EGLIN AIR FORCE BASE, FLORIDA
JSF ACADEMIC TRAINING CENTER (ATC)
PROJECT NO. FTFA083950
AS-BUILT
MECHANICAL PIPING
FIRST FLOOR PLAN
— AREA A

EGLIN AIR FORCE BASE, FLORIDA
JSF ACADEMIC TRAINING CENTER (ATC)
PROJECT NO. FTFA083950
AS-BUILT
MECHANICAL PIPING
FIRST FLOOR PLAN
AREA B

EGLIN AIR FORCE BASE, FLORIDA
JSF ACADEMIC TRAINING CENTER (ATC)
PROJECT NO. FTFA083950
AS-BUILT
CHILLED WATER SYSTEM
CONTROL SCHEMATIC
SEQUENCE & POINTS LIST

AS-BUILT
PLUMBING
BELOW RAISED FLOOR &
BELOW GRADE PLAN AREA A

M-112

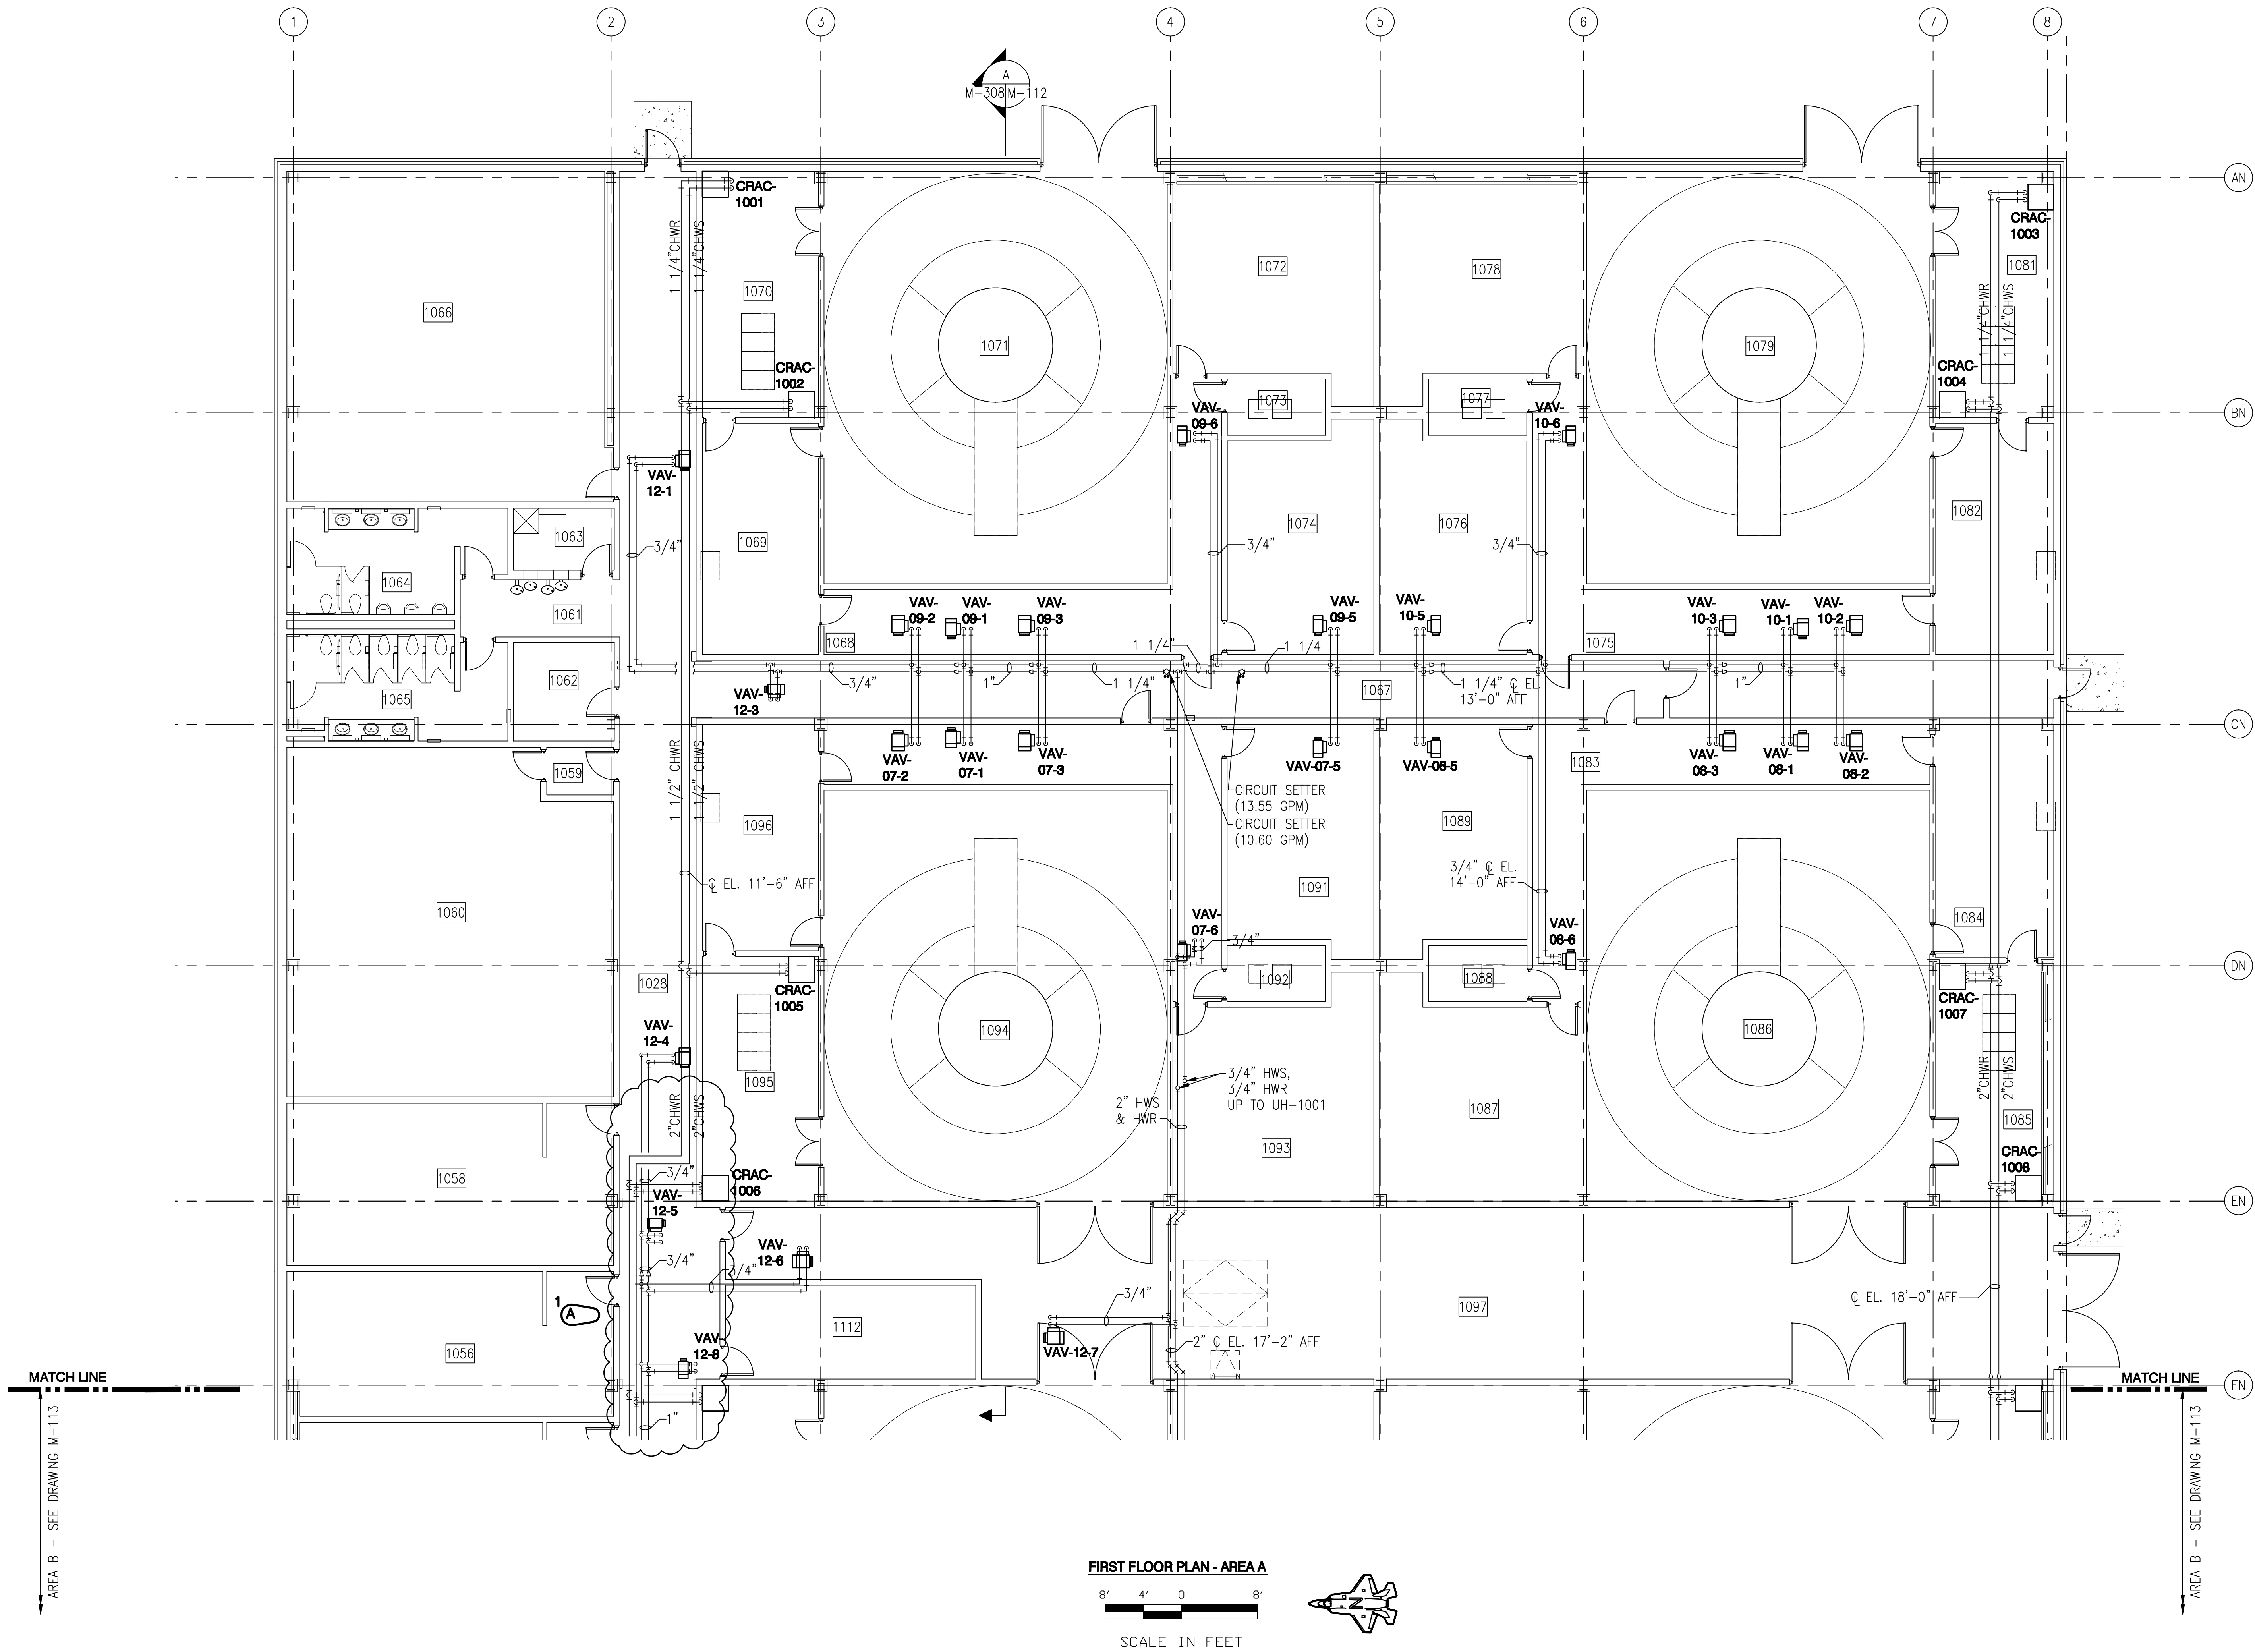
Symbol	No.	Description	Date	Approved
AS-BUILT	1	FIELD CHANGE - RELOCATED CHILLED WATER SUPPLY AND RETURN

M-113

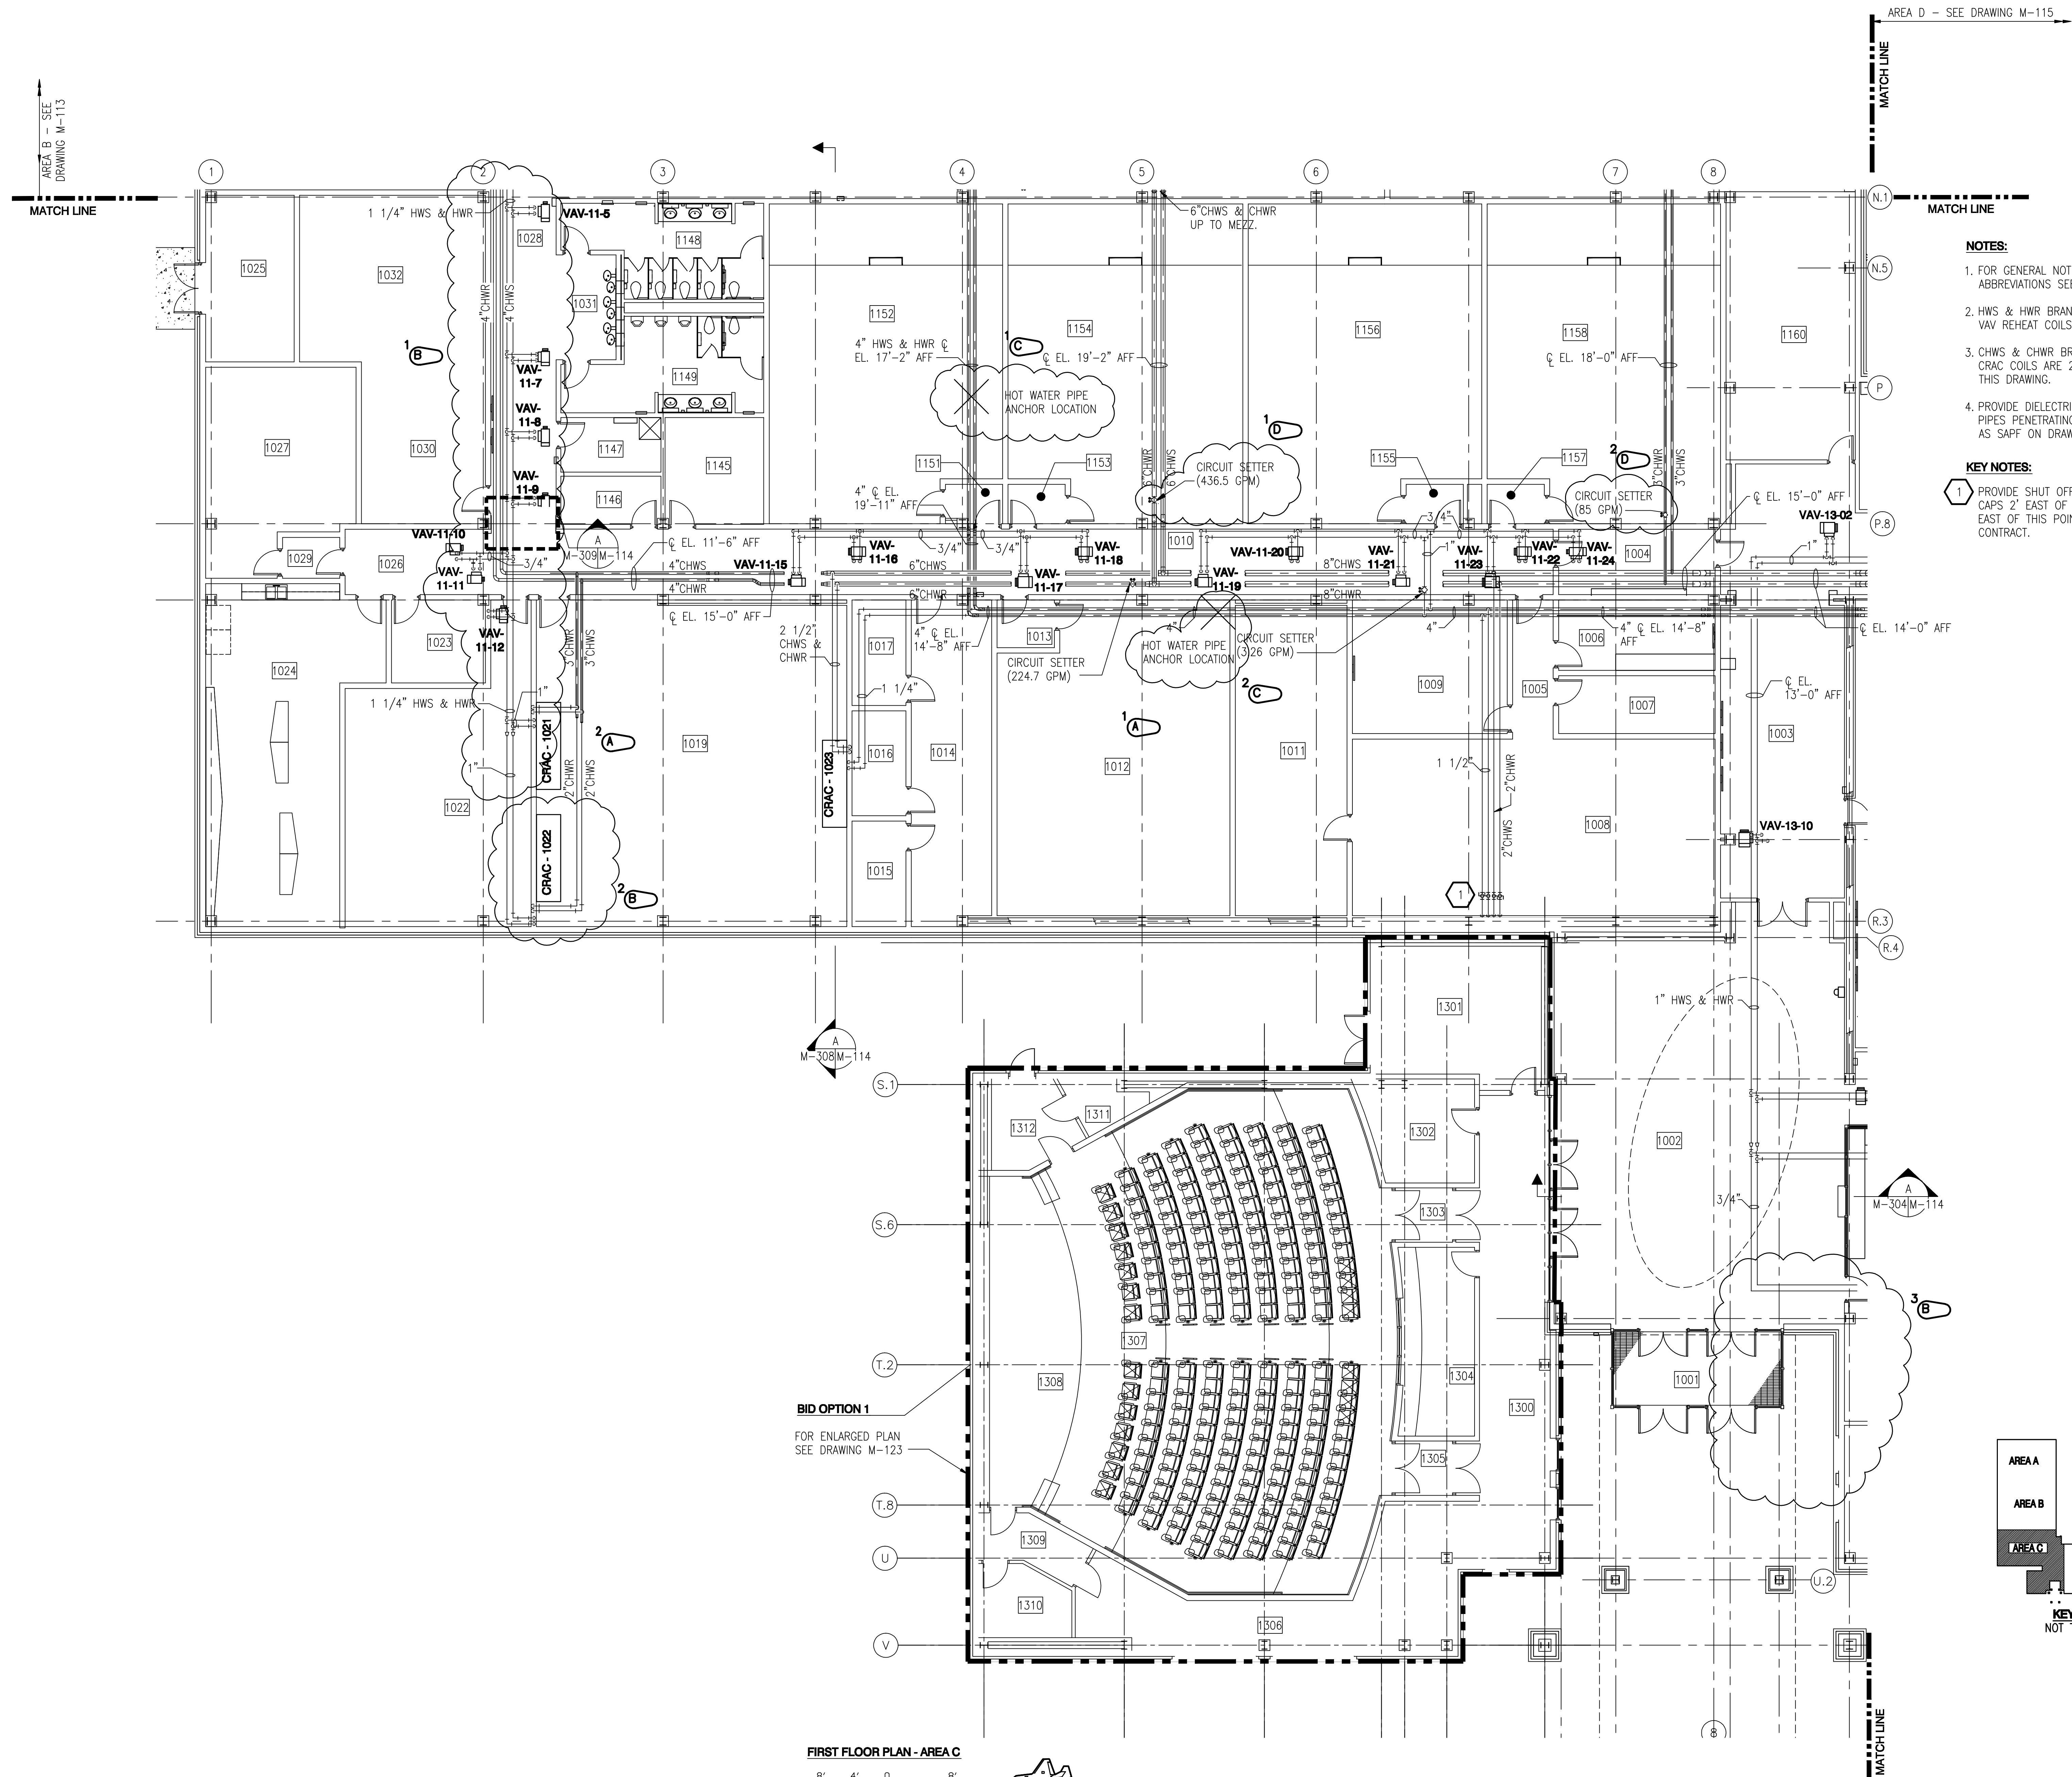
Symbol	No.	Description	Revisions
1	AS-BUILT: PIPE GUIDE LOCATION		
1	AS-BUILT: HOT WATER PIPE ANCHOR LOCATION		
1	AS-BUILT: FIELD CHANGE - RELOCATED CHILLED WATER SUPPLY AND RETURN		
1	REVISED PER RFI-0070		
		Date	7/21/09
		Approved

M-114

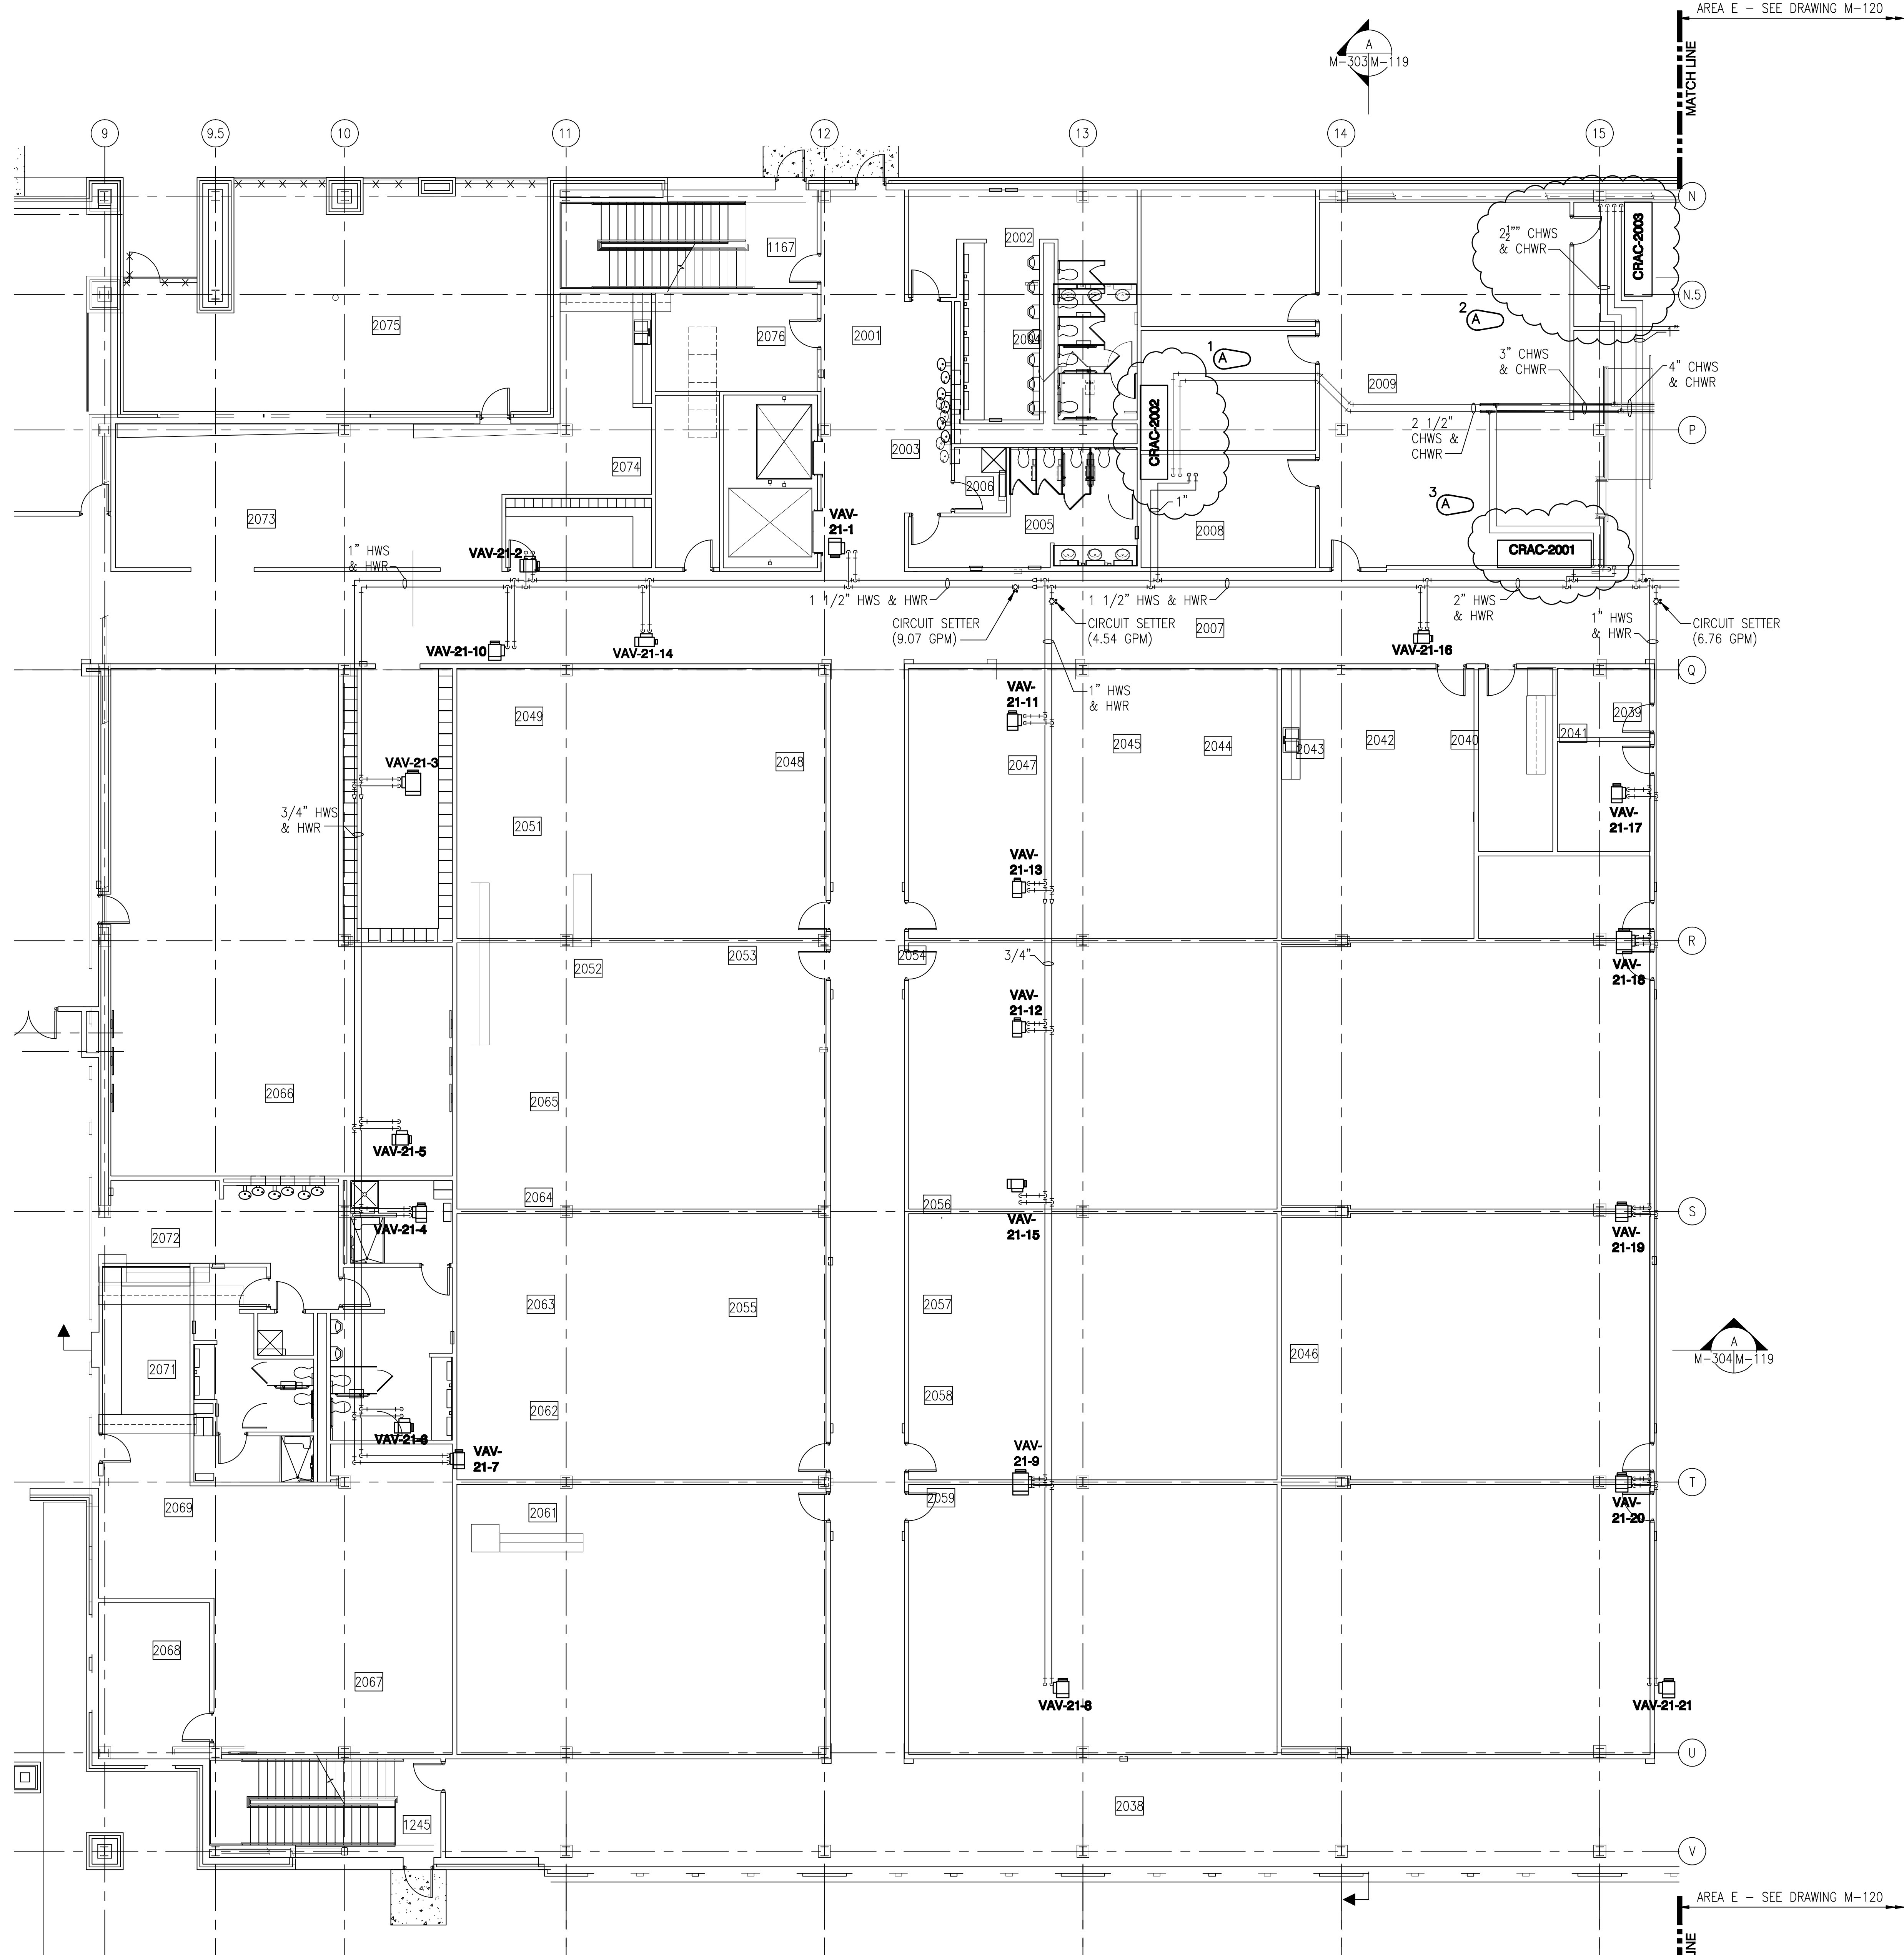
Symbol	No.	Description	Revisions
1	AS-BUILT - RELOCATED CIRCUIT SETTERS		
2	AS-BUILT - HOT WATER PIPE ANCHOR LOCATION		
3	AS-BUILT - FIELD CHANGE - RELOCATED CHILLED WATER/HOT WATER SUPPLY AND RETURN		
2	AMENDMENT NO. 0003		
9/12/08	Date		
Approved
